**PATENT
K-1786**

RESPONSE TO FINAL OFFICE ACTION OF FEBRUARY 8, 2007

In re Application of OJANEN)
Serial No. 09/838,348) Group Art Unit 3673
Filed: April 19, 2001)
For: ROTATABLE CUTTING TOOL) Examiner: Singh, Sunil
HAVING RETAINER WITH DIMPLES)

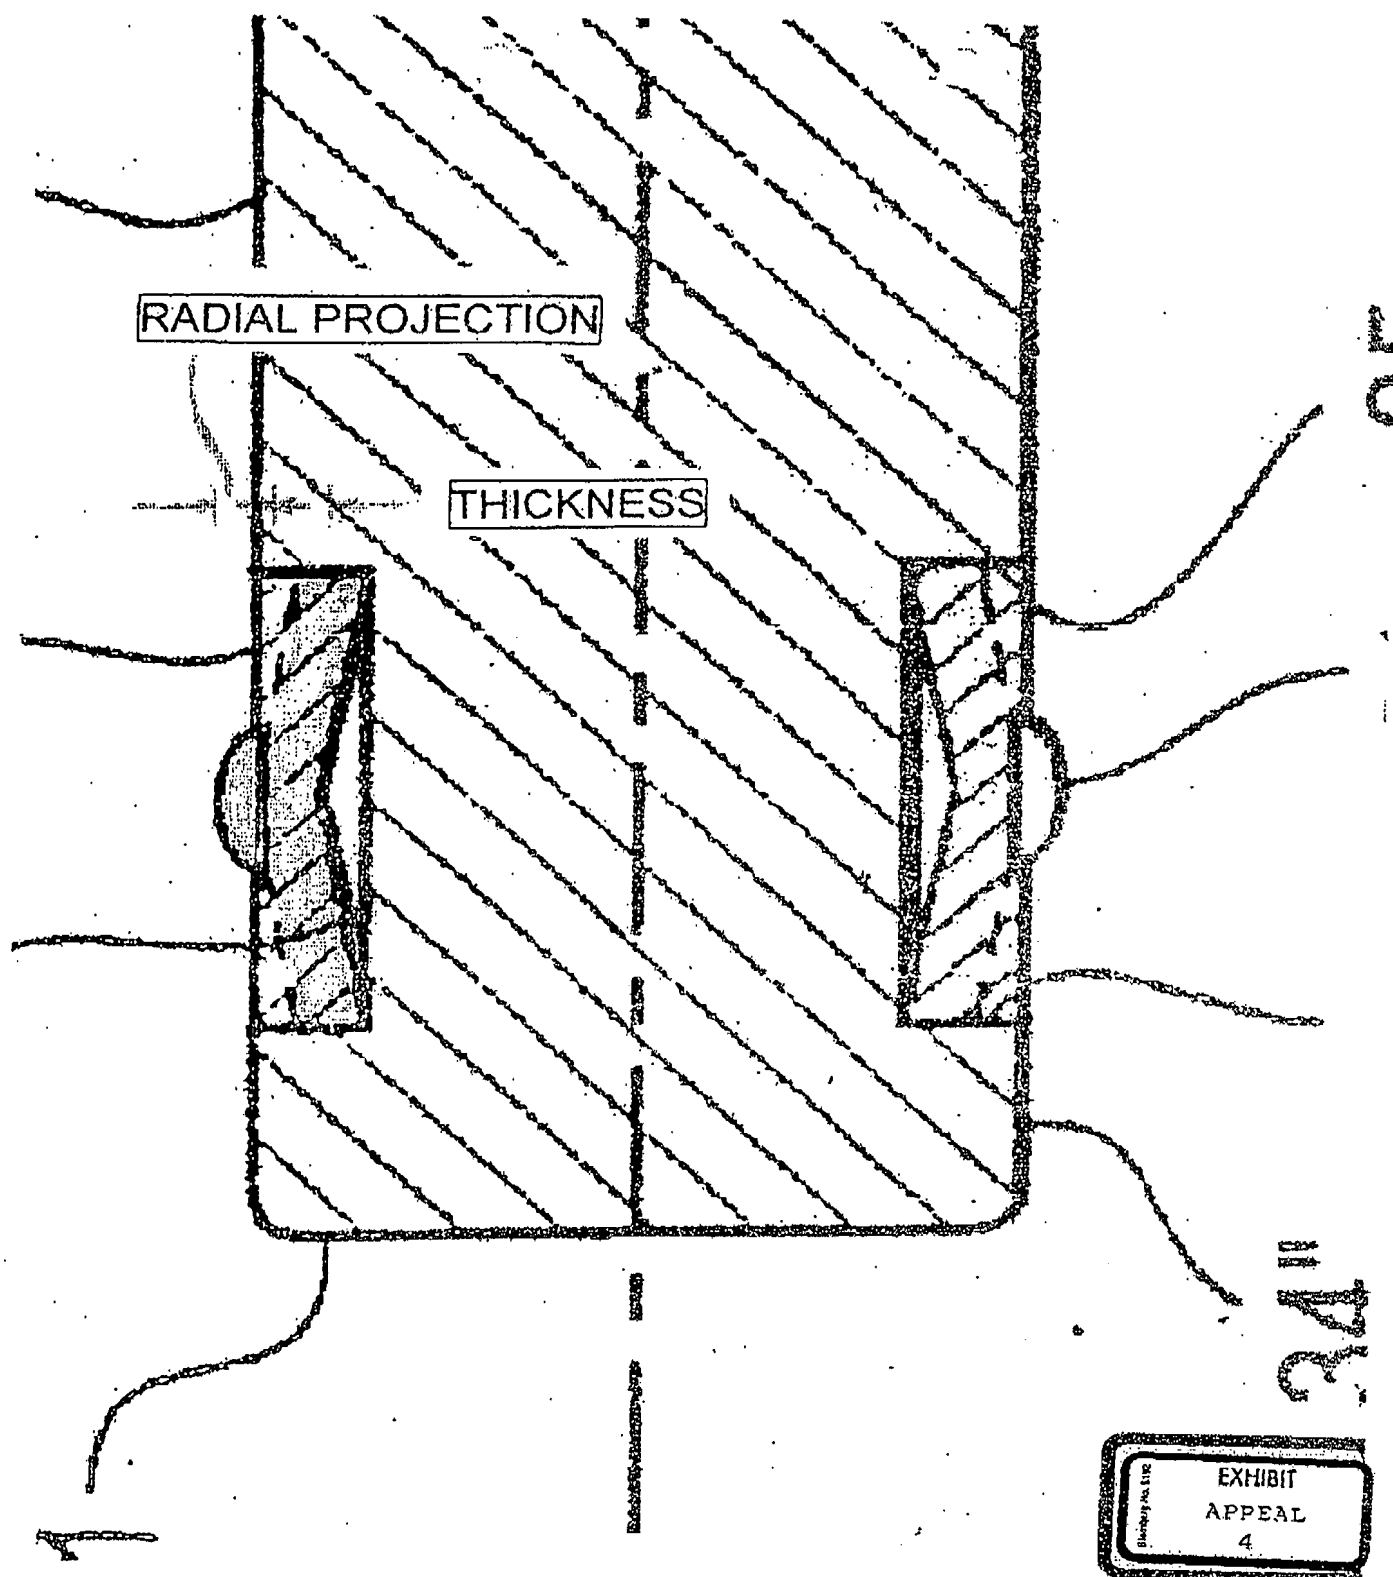
In addressing the numerical range as set forth in the claims, the Examiner used the '652 Sollami Patent and wrote, "... the amount of radial projection of said protruding surface beyond the cylindrical surface of the retainer is between about 15 percent and about 30 percent of the thickness dimension of said retainer (see Fig. 15)." See page 4 of the FINAL Office Action of June 6, 2005. Attached hereto as Appeal Exhibit 4 (i.e., Exhibit H attached to the Response to the Non-Final Office of February 1, 2005) is an enlarged copy of

the tool illustrated in Fig. 15 of the '652 Sollami Patent. Measurement of the thickness of the retainer ("THICKNESS" in Exhibit H) in comparison to the distance of the radial projection ("RADIAL PROJECTION" in Exhibit H) establishes that the radial projection is about 88.9 percent (RADIAL PROJECTION/ THICKNESS) of the thickness of the retainer.

In light of this measurement of the radial projection equaling about 88.9 percent, appellant submits that the '652 Sollami patent cannot anticipate the claims under 35 USC §102(e) wherein the claims call for a lesser degree of projection.

Enlargement of FIG. 15 of US Patent No. 6,397,652

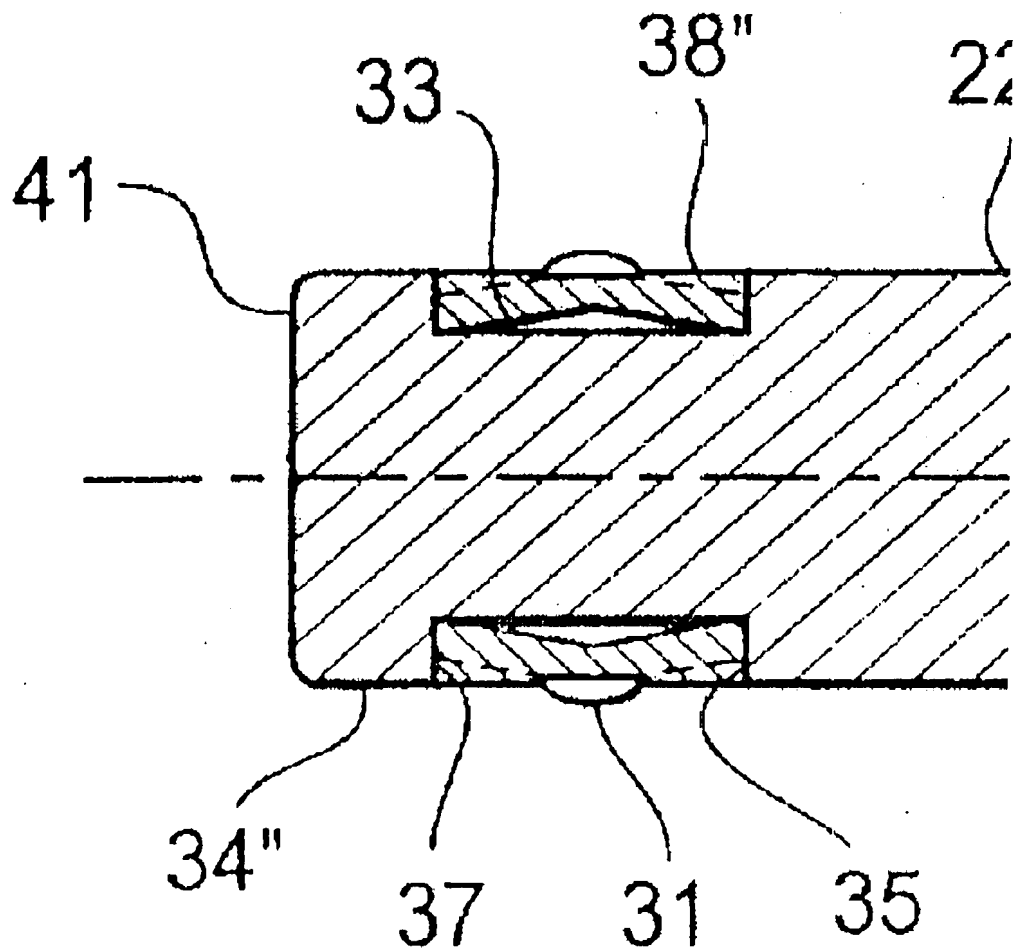
First, a careful review reveals that FIG. 15 illustrates the retainer body in cross-section and the protrusion is not in cross-section⁴ (see Attachment B, which is an enlarged version of FIG. 15). Basic drafting principles establish that the protrusion of FIG. 15 must be rotated away from the section line. What this means is that the extent of the radial outward projection of protrusion is actually greater than what FIG. 15 shows. Since there is no description as to the extent of the rotation, there is no way to accurately determine the extent of the radial outward projection. This is a fundamental flaw in the Primary Examiner's use of FIG. 15 from Sollami.⁵

Second, a careful look at an enlarged version of FIG. 15 (see Attachment B) shows that the retainer sleeve (38") is somewhat arcuate and is of a generally constant thickness. The fact that retainer sleeve 38" is of a generally constant thickness is consistent with the illustrations of sleeves 38 and 38' in FIGS. 3 and 3A, as well as the broken lines of each surface of the retainer shows that retainer sleeve 38" is of a generally consistent thickness. An enlarged view (Attachment B) of the rear portion of the tool (10") of FIG. 15 establishes that the thickness is generally consistent.

ATTACHMENT C

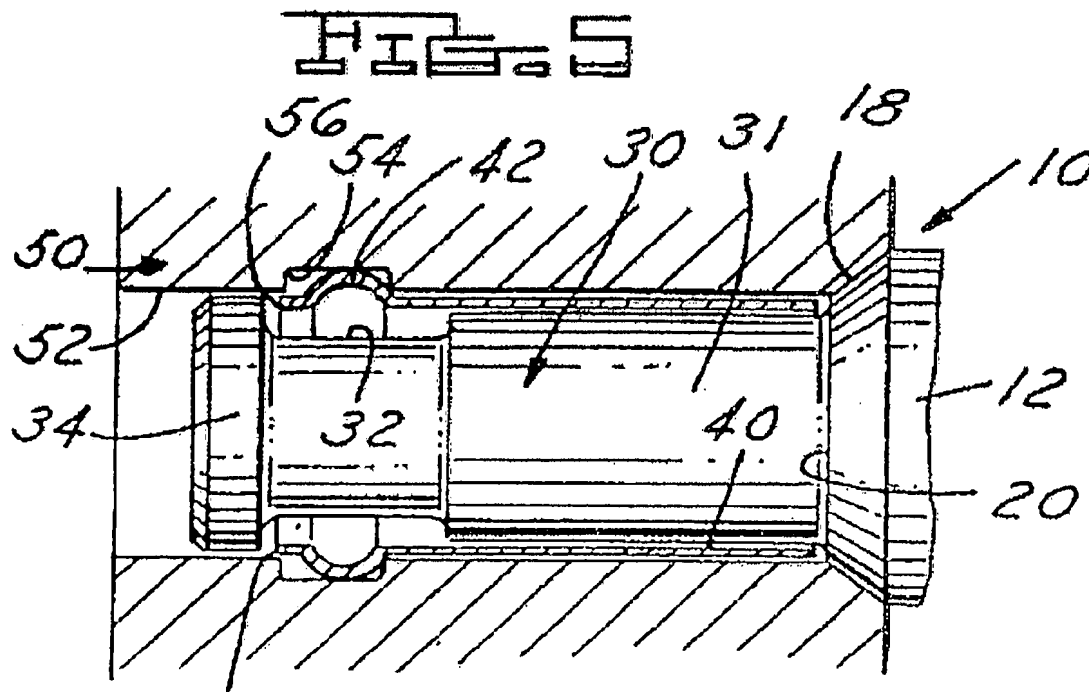
⁴ FIG. 5 of U.S. Patent No. 4,484,783 to Emmerich (of record in this case) shows both the retainer body and dimple in cross-section. See Attachment C hereto.

Reproduction of the Examiner's Measurements

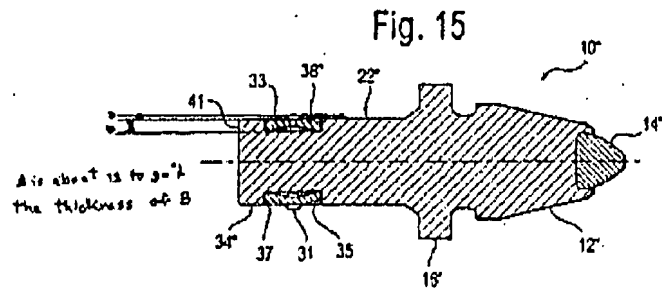
8. Applicant's arguments filed in appeal brief (filed 10/07/05) have been fully considered but they are not persuasive. Applicant argues that the dimple thickness is about 88.9% the thickness of the sleeve. The examiner disagrees. As pointed out in the attached marked up Figure 15, member (41) is defined at col. 6 line 55 as being .1875 inches and it was determined by measurement that the dimple thickness is about .0375 and the sleeve thickness is about .125 inches thus meeting the limitation about 15-30%.

As shown by the enlargement of the Primary Examiner's marked-up copy of FIG. 15 (an enlargement is Attachment D), the Primary Examiner takes a measurement such that the thickness of the retainer (dimension "b" in the attachment to the Office Action) is equal to the depth of the groove (33).⁶ This is inconsistent with the drawing that shows

broken lines as representing the surface of the retainer. To the extent that a measurement of the thickness of the retainer is proper, a measurement of the thickness dimension "b" should be taken to correspond to the thickness of the retainer as shown by the broken lines.
